### MIDDLE ST. CROIX WATERSHED MANAGEMENT ORGANIZATION

# Regular Meeting of the Middle St. Croix Watershed Management Organization Remotely held as posted on www.mscwmo.org

Physical location - Washington Conservation District, 455 Hayward Ave N Thursday, May 8<sup>th</sup>, 2025 6:00PM

Table 5-2. Regionally Significant Rivers and Streams for Pollutant Reductions (See Figure 5-2)

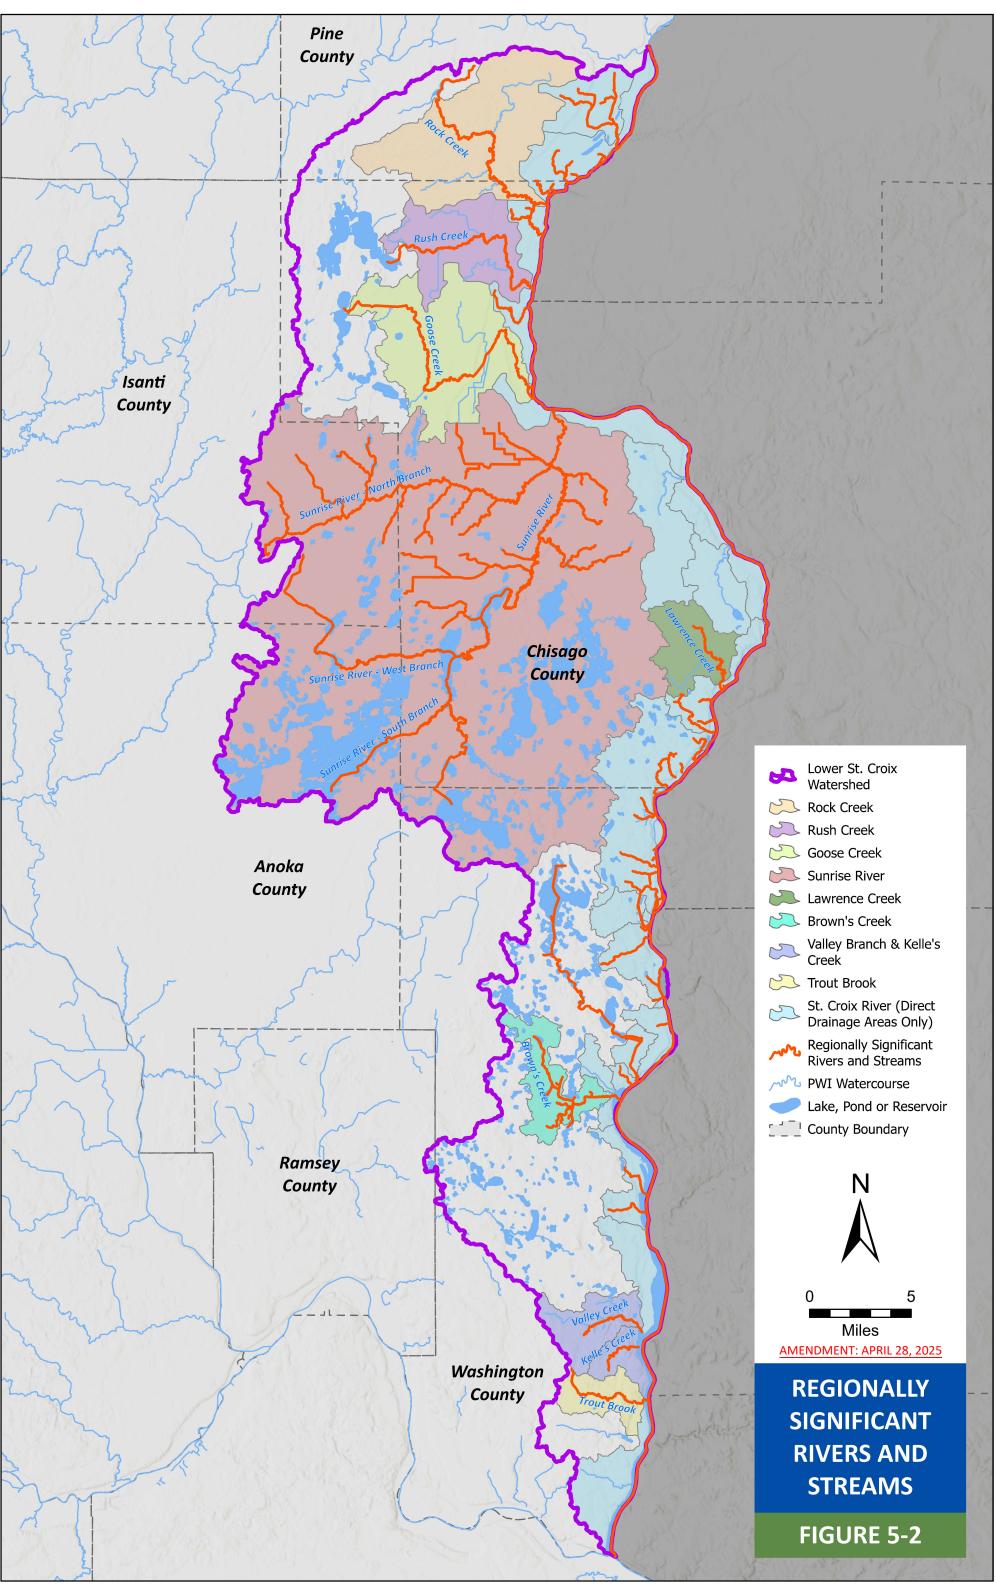
3) Modify Figure 5-2 (Regionally Significant Rivers and Streams) as attached to include subwatershed boundaries of the areas identified in the amended Table 5-2, consistent with the existing definition of "Direct drainage and direct catchments" on page 59 of the Plan:

Making the minor changes in items #2 through #4 above will correct an ongoing situation whereby the Plan, as currently written, does not recognize its titular waterbody as a regionally significant waterbody worth protecting through implementation of pollutant reductions as otherwise prescribed within the Plan. The modified load reduction goals for direct drainage areas in Table 5-2 are pulled directly from the Lake St. Croix TMDL. The amendment further clarifies the specific exclusion of local land-locked basins consistent with the original intent of the Plan.

The LSCWP Policy Committee recommends that all LSCWP local governing boards approve the proposed minor amendments as shown in the attached markup plan pages (Pages 61, 66, 75, 78, 81, and Figure 5-2).
